the BUILDING CONSULTANT

Field Report **Attorney work Product** **Project Information**

15 Feb 2025

Field observation report for:**Overview:**

LP Paint and Finish

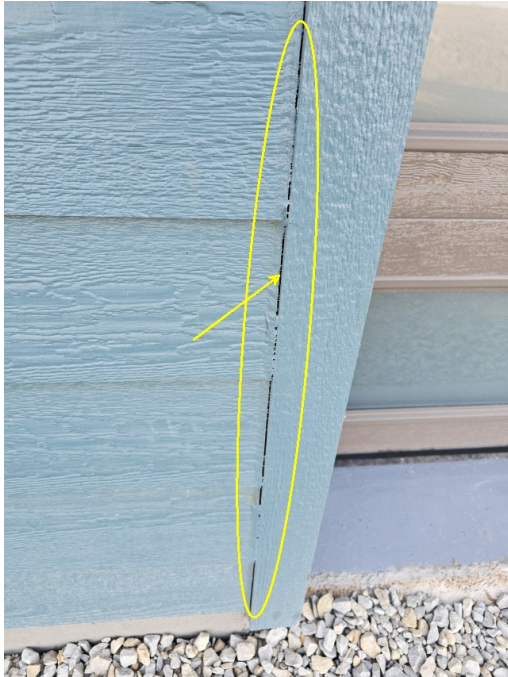
Siding not sealed and painted at the bottom curt edge as required by LP SmartSide

Siding Attachment to Walls

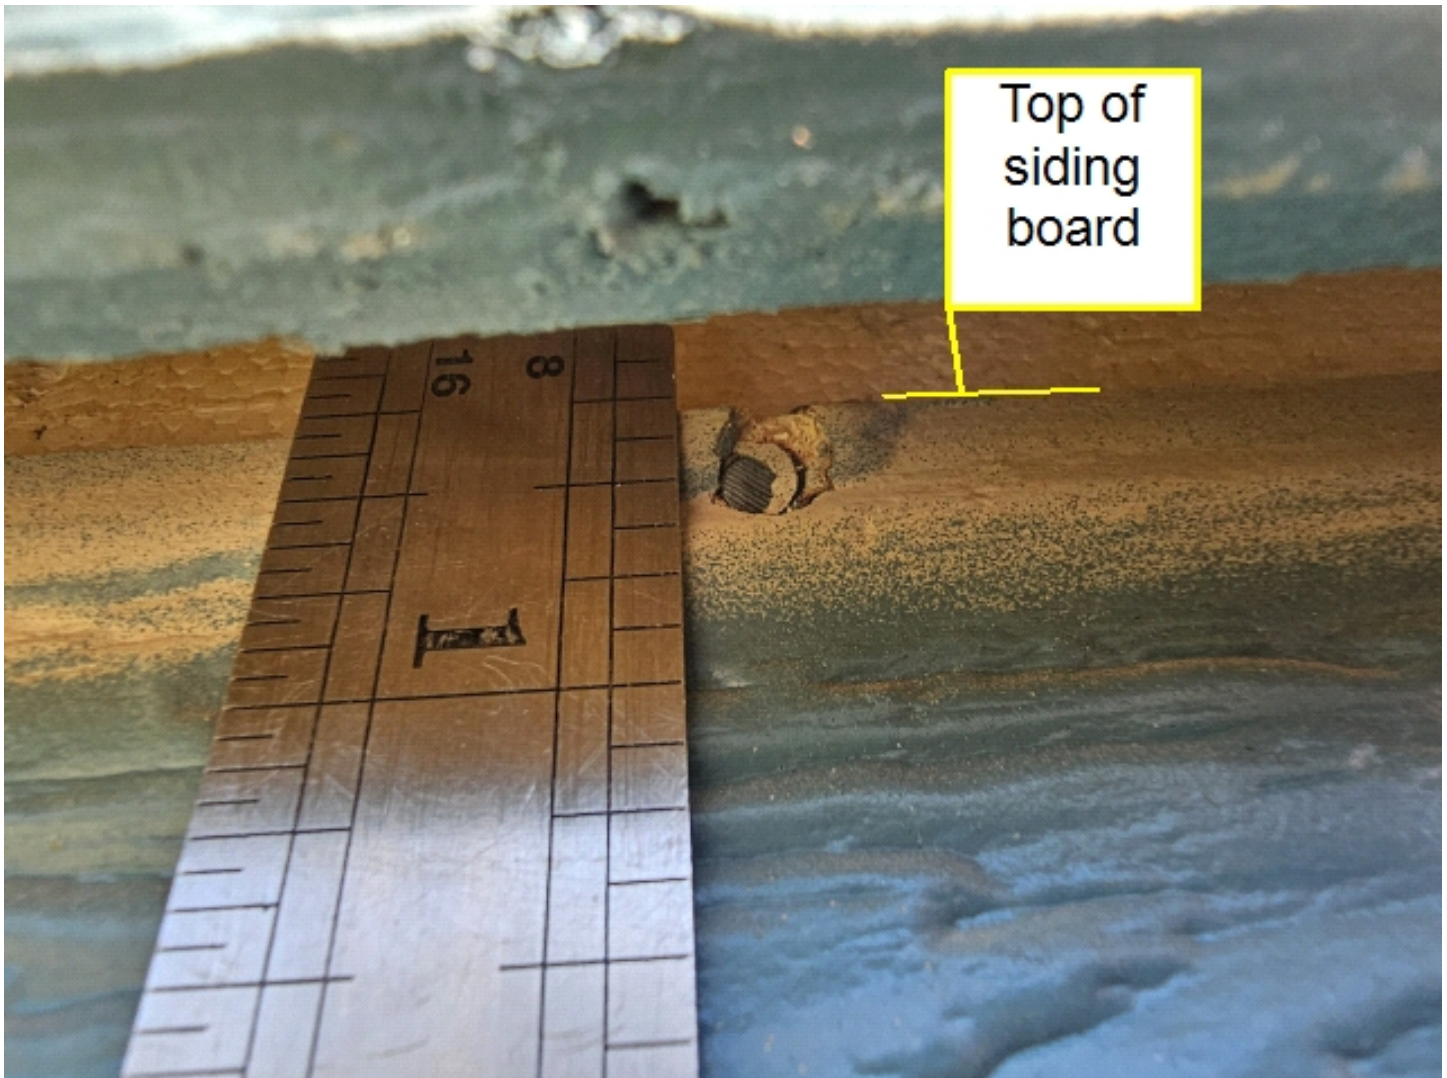
- **Insulated Concrete Forms (ICF) Assemblies.** LP is specific in its requirements for attachment of their siding products to the walls of the home.
 - • Siding must be fastened with:
 - - Min. #8 stainless steel or equivalent, self-drilling tapered head screw.
 - - Min. penetration of 3/8 inch (10 mm) beyond the thickness of the nailing flange.
 - • Larger screws may be required by ICF Manufacturer based on the following min. withdrawal requirements.
 - - Min. withdrawal value of ICF nailing flange must be 50 lbs. (23 kg) with max. 12 inches (305 mm) o.c. spacing.
 - - Min. withdrawal value of ICF nailing flange must be 31 lbs. (14 kg) with max. 6 inches (152 mm) o.c. spacing.

Siding is LP SmartSide 8" horizontal lap siding.

Siding Attachment to Walls

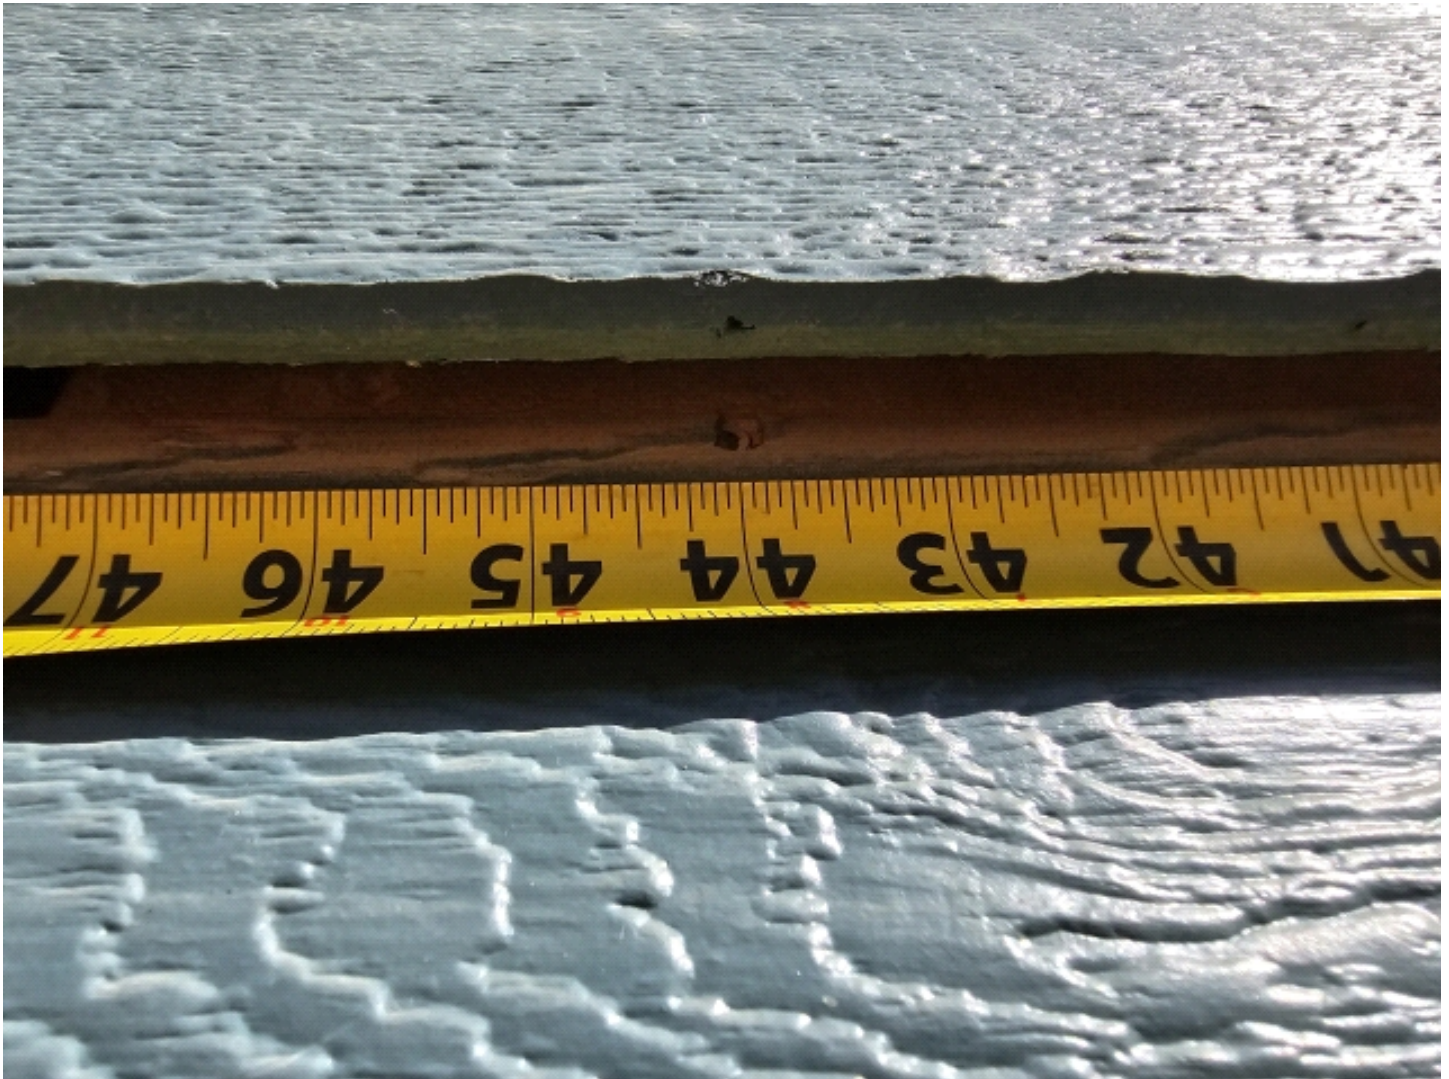
Fasteners are to be placed 3/4" down from the top of the board.
The placement is wrong and the type of fastener is wrong

Lower Level Garage

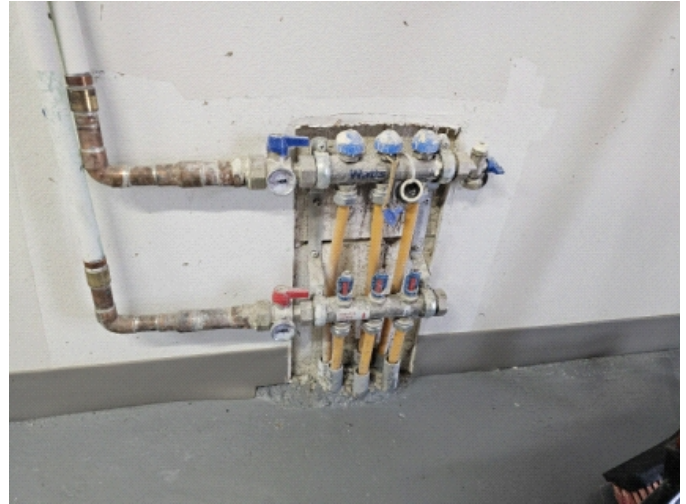
Lower level garage. Foundation is not properly waterproofed and water is intruding creating an issue that wets the drywall resulting in a microbial action taking place on the back side of the drywall.

Plumbing pipes set poorly into the ICF forms not allowing drywall to be placed behind the pipe.
Poor workmanship

Interior Finishes

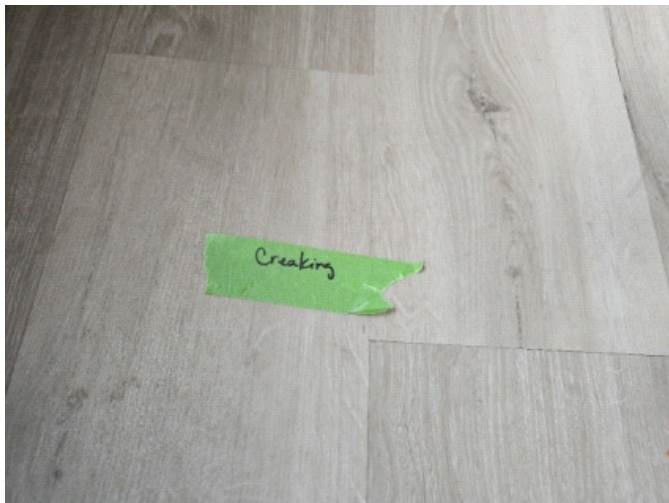
Builder's idea of how to adjust door. Door was not set properly, which required some adjustment. So the builder hacks out the hinge pocket in an attempt to adjust the door.

Undercut saw damaged trim.
